APPEAL SUMMARY

Appeal ID: 22227	Project Address: 7200 NE Airport Way
Hearing Date: 12/18/19	Appellant Name: Tom Jaleski
Case No.: B-002	Appellant Phone: 9712385266
Appeal Type: Building	Plans Examiner/Inspector: David Bartley
Project Type:	Stories: 2 Occupancy: A-3, B, M, S-1 Construction Type: I-A
Building/Business Name: PDX	Fire Sprinklers: Yes - throughout
Appeal Involves: Erection of a new structure	LUR or Permit Application No.:
Plan Submitted Option: pdf [File 1]	Proposed use: Airport

APPEAL INFORMATION SHEET

PORTLAND INTERNATIONAL AIRPORT
PDXNEXT TCOE
ENPLANING - COORDINATION PLAN

PDXNEXT TCORE
MEZZANINE - COORDINATION PLAN

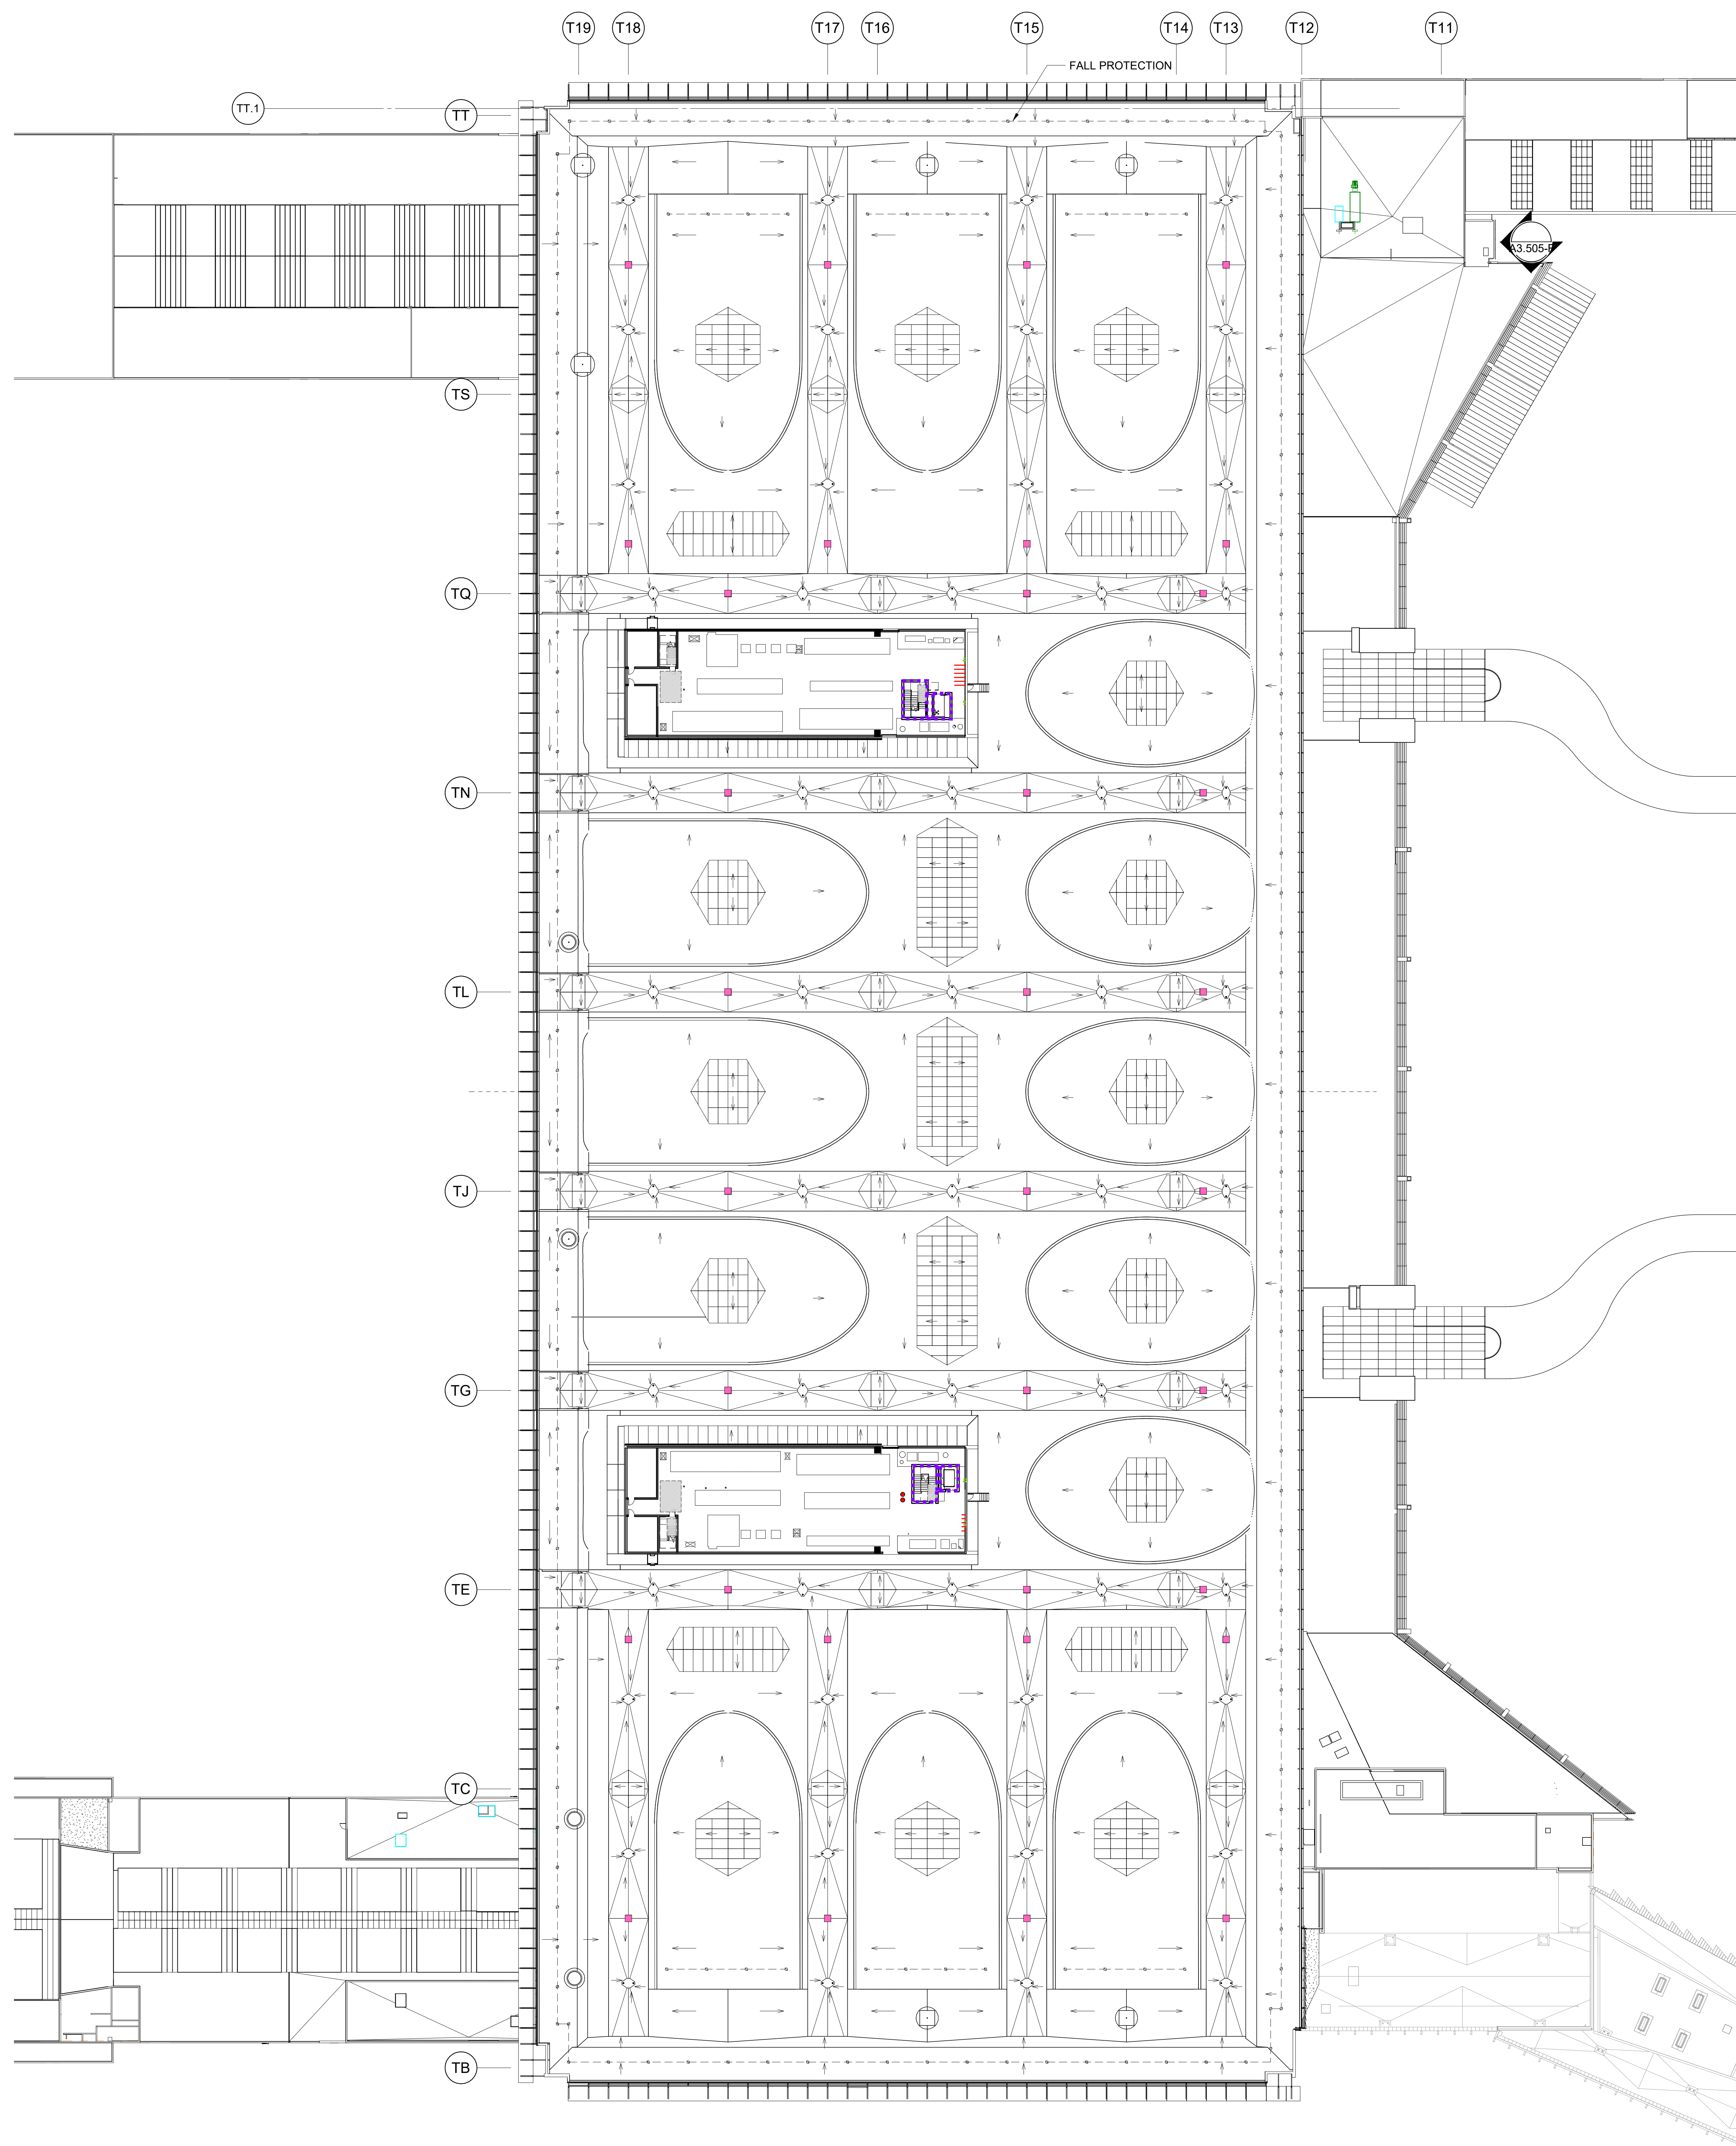
Proposed Design PDX TCORE project will provide an addition to the existing main terminal area, add a new mezzanine, and reconfigure the existing terminal building on the departure level. Egress from the new mechanical penthouse, new mezzanine, and new terminal addition will by interior exit stairways down to the level of exit discharge and through exit passageways to the exit discharge on the airside of the terminal.
